FILE P. I. No. 110700-, Franklin County **OFFICE** Preconstruction
NH-IM-85-2(174)
I-85 Widening from North of SR 320 **DATE** April 9, 2008
To North of SR 17

SUBJECT APPROVED REVISED PROJECT CONCEPT REPORT

SUBJECT Revised Project Concept Report

REVISED PROJECT CONCEPT REPORT

1-85 LANE TYPICAL SECTION
TANGENT SECTION
EXISTING 140' MEDIAN

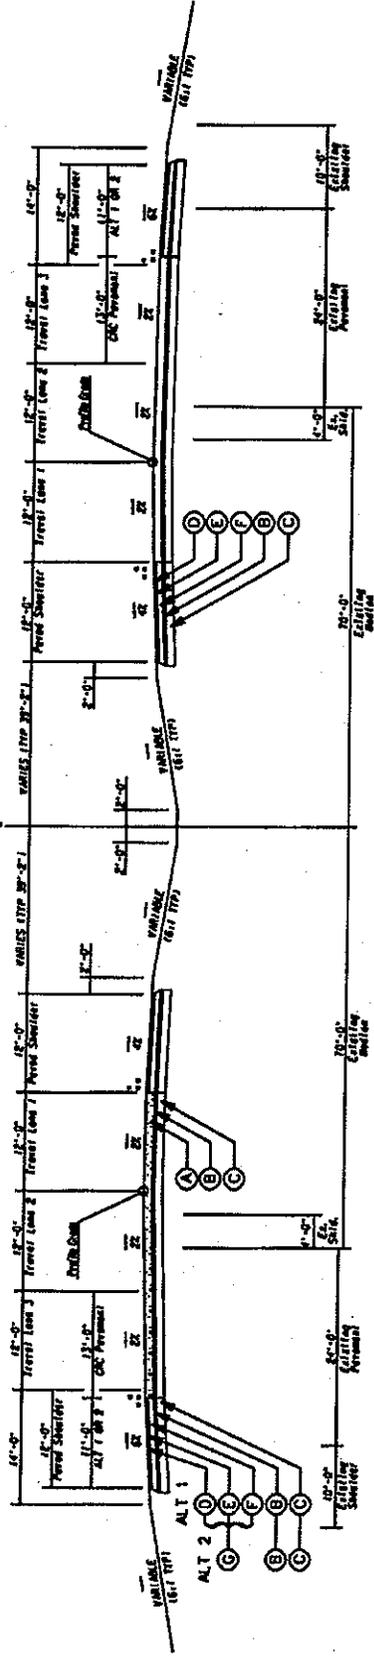
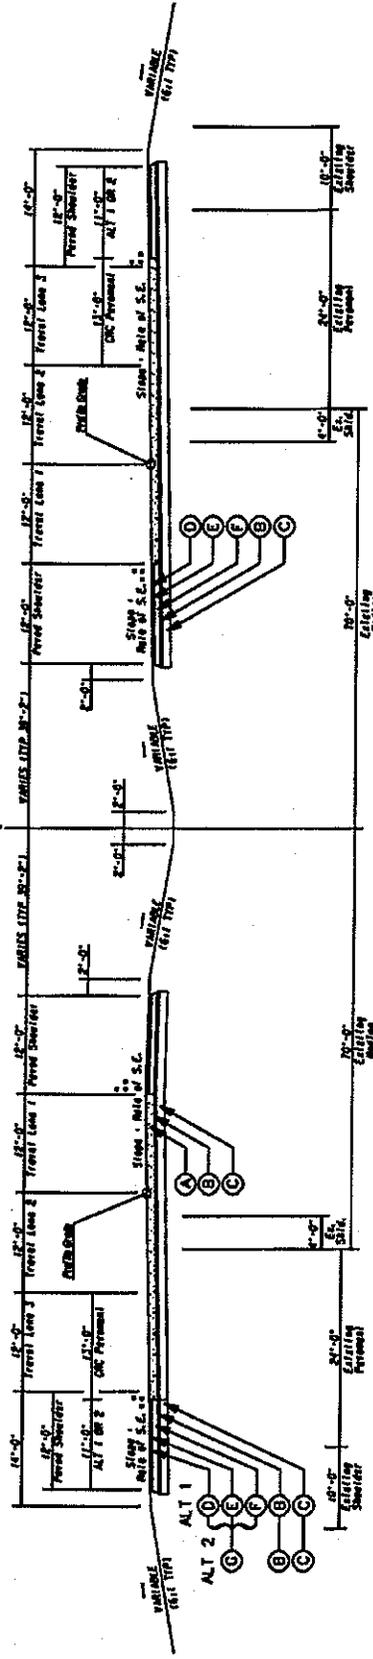
- **The revised typical section:**

Mile log 164.4 – 171.8 & 172.6 – 173.5

- o Six 12' lanes, outside lane paving will extend 1'-0" into the paved outside shoulder but will be striped at 12'-0"
- o Median Barrier (Type S-1, S-2 or S-3)
- o 13'-2" inside shoulder (12' paved)
- o 14' outside shoulder (12' paved), includes 1'-0" extension of outside lane pavement
- o Concrete pavement section with full depth reconstruction of existing pavement and an alternative pavement section (asphalt or concrete) for the paved shoulders

Mile log 171.8 – 172.6

- o Six 12' lanes, outside lane paving will extend 1'-0" into the paved outside shoulder but will be striped at 12'-0"
- o 102'-4" depressed median
- o 14' inside shoulder (12' paved)
- o 14' outside shoulder (12' paved), includes 1'-0" extension of outside lane pavement
- o Concrete pavement section with full depth reconstruction of existing pavement and an alternative pavement section (asphalt or concrete) for the paved shoulders
